SURGENOR TRUCK CENTRE ADDITION & RENOVATIONS
1571 Liverpool Court, Ottawa, Ontario.

ADDENDUM No. 3 - Revision 1 to Drawings and Specifications
Job No. 18-18 - 20 February 2019

**STRUCTURAL
TENDER ADDENDUM**

ADDENDUM # E002

DWG. No.: STA-1-SK1

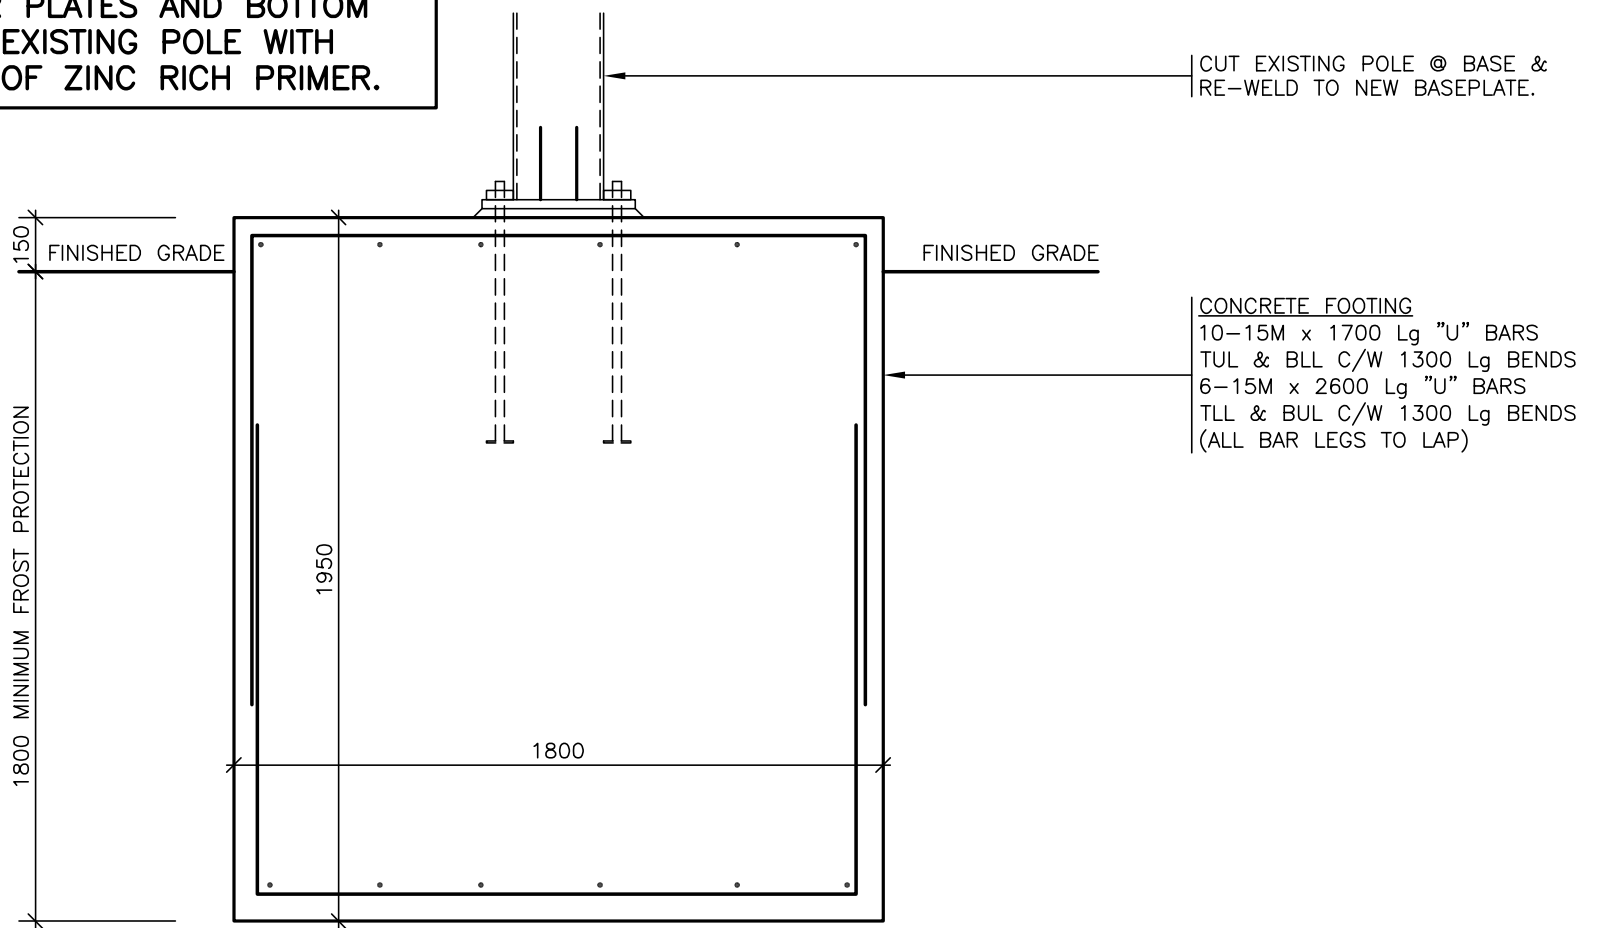
NEW BASEPLATE
 425 x 875 x 25 THK C/W
 8-25 ϕ HEADED ANCHORS
 (625 mm EMBEDMENT) C/W
 2-10 THK x 200 HIGH
 STIFFENER PLATES EACH SIDE

**CONCRETE COVER
 FOOTING**
 75 mm BOTTOM
 50 mm TOP & SIDES

CONCRETE COMPRESSIVE
 STRENGTH @ 28 DAYS
 TO BE 35 MPa CLASS C1
 w/ 5-8% AIR
 ENTRAINMENT

**COVER NEW BASEPLATE, ANCHORS,
 STIFFENER PLATES AND BOTTOM
 FOOT OF EXISTING POLE WITH
 2 COATS OF ZINC RICH PRIMER.**

CUT EXISTING POLE @ BASE &
 RE-WELD TO NEW BASEPLATE.

CONCRETE FOOTING
 10-15M x 1700 Lg "U" BARS
 TUL & BLL C/W 1300 Lg BENDS
 6-15M x 2600 Lg "U" BARS
 TLL & BUL C/W 1300 Lg BENDS
 (ALL BAR LEGS TO LAP)

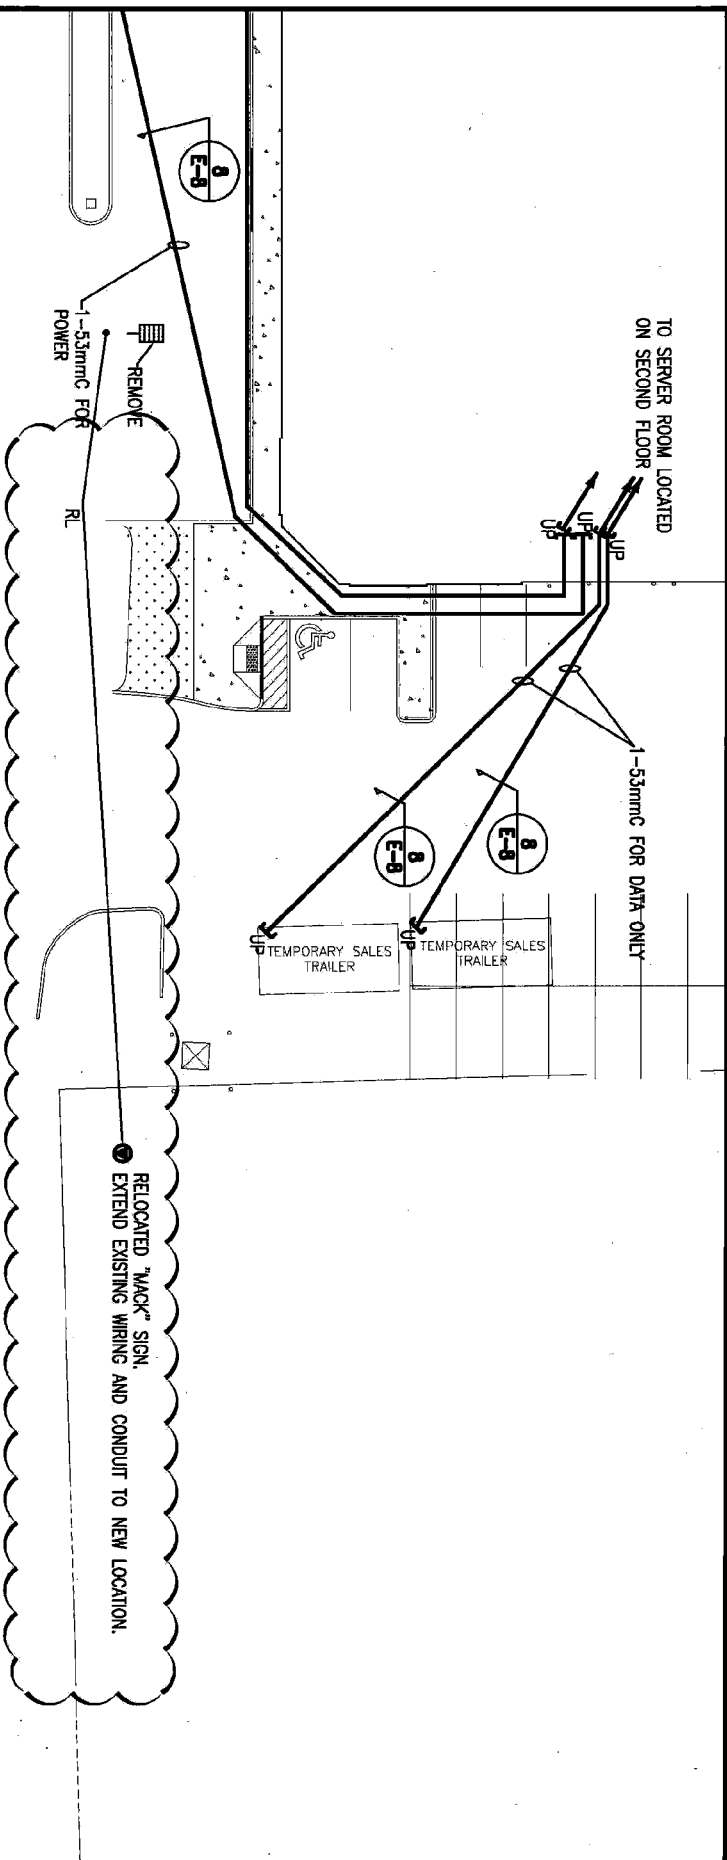
- .1 Revise site plan, and feeders to roof top units and new 30KVA transformer as indicated on attached sketches SKE-ADDE002A to C.

**REVISE DESCRIPTION
OF WORK**

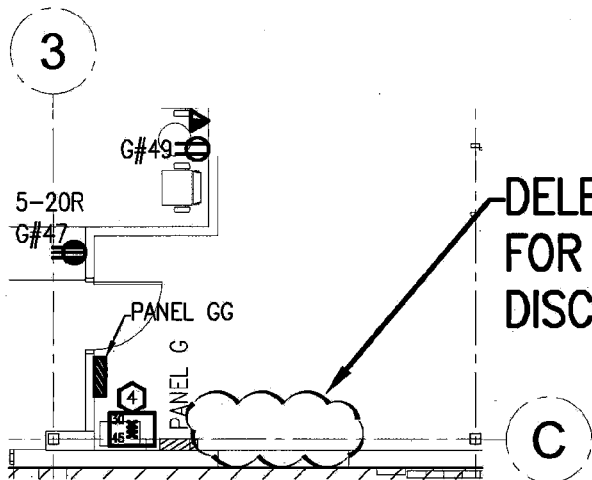
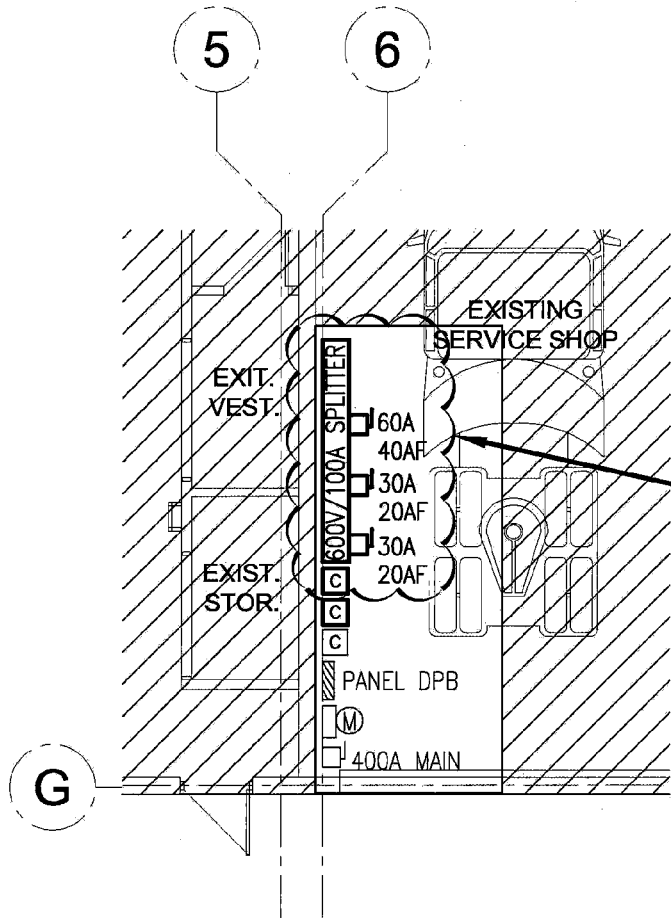
DELETE REQUIREMENT FOR SPLITTER AND DISCONNECT SWITCH

ADD SPLITTER AND DISCONNECT SWITCHES. ENSURE THERE IS SPACE ON SPLITTER FOR TWO ADDITIONAL DISCONNECT SWITCHES.
